## RE: AWDM/0153/25 - Queens Parade North Road Lancing West Sussex

We are writing in response to the latest comments from West Sussex County Council as the Lead Local Flood Authority (LLFA), received 18<sup>th</sup> March 2025. This response states;

We understand that the NaFRA2 mapping has been updated. Please see below for the amended surface water flood risk section of the report. This section below is an addendum to the existing Flood Risk Assessment (document reference: AEG5636\_BN15\_Lancing\_07) and should be referred to ahead of Sections 4.9 – 4.18.

Figure 1: EA Surface Water Flood Risk Mapping Climate Change Extent (Base map and data from OpenStreetMap and OpenStreetMap Foundation (CC-BY-SA). © <https://www.openstreetmap.org> and contributors)

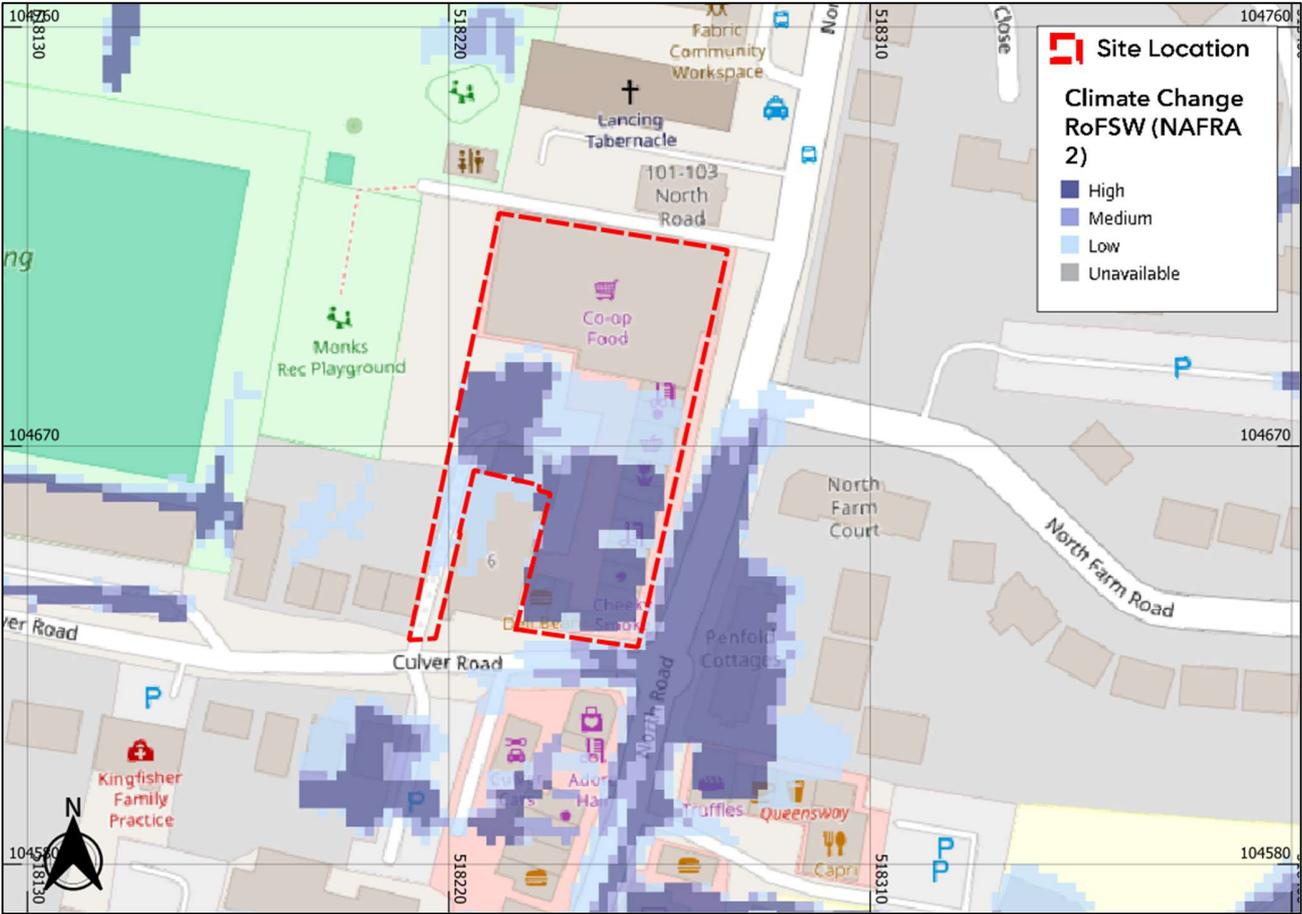
*1) The Environment Agency has recently updated its flood risk modelling (NaFRA2) and this has resulted in a change of surface water flood risk profile at this site.*

*Please update the Flood Risk Assessment using the latest data.*

The EA Online ‘Flood Risk from Surface Water -Climate Change’ map (Jan 2025) indicates that the site is at a ‘high’ ‘medium’ and ‘low’ risk of surface water flooding (Figure 1 **Error! Reference source not found.**). However, it is important to note that the ‘high’ surface water flood extent is associated with a topographical low point on the site, rather than an overland flow path from offsite. As such, this can be managed appropriately by SuDS (Sustainable Drainage Systems).

Drawing Title  
 Utility Survey of Land at:  
 Queens Parade  
 Lancing

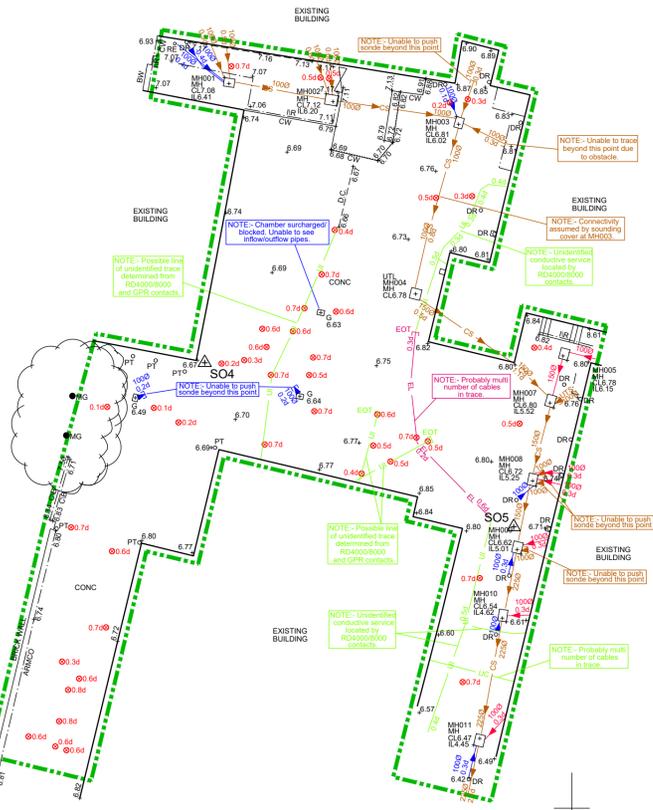
*2) Following the SuDS Hierarchy, the Applicant has stated that the only method of surface water discharge is to the existing foul sewer (which it is contended should be classified as a combined sewer due to existing surface water connections).*

*Following discussions with Southern Water, they have advised they classify this as a foul only sewer, irrespective of any existing connection. It is noted on our mapping that there is a private surface water system adjacent to the foul sewer in North Road. It must be demonstrated that the applicant has explored the private surface water system in order to follow the SuDS hierarchy. We would suggest contacting WSCC Highways and the Adur & Worthing Councils in the first instance to assist in ascertaining who manages and maintains this asset. When/if the asset owner is identified, we will need evidence that the asset owner is content for connections to be made. As this may be unsuitable for submitting to planning portal, we are happy for this to be sent to the email below.*

The submitted drainage strategy utilises the existing outfall connection, which is acknowledge discharges into a sewer owned by Southern Water. The CCTV survey evidence (Appendix A) confirms that this sewer actively receives surface water runoff from the site and potentially other off-site sources. Aegaea believe this asset's function reflects the historical drainage practice prevalent in the South Coast region, where SuDS were often not prioritised, resulting in surface water being directed into what are legacy combined sewers.
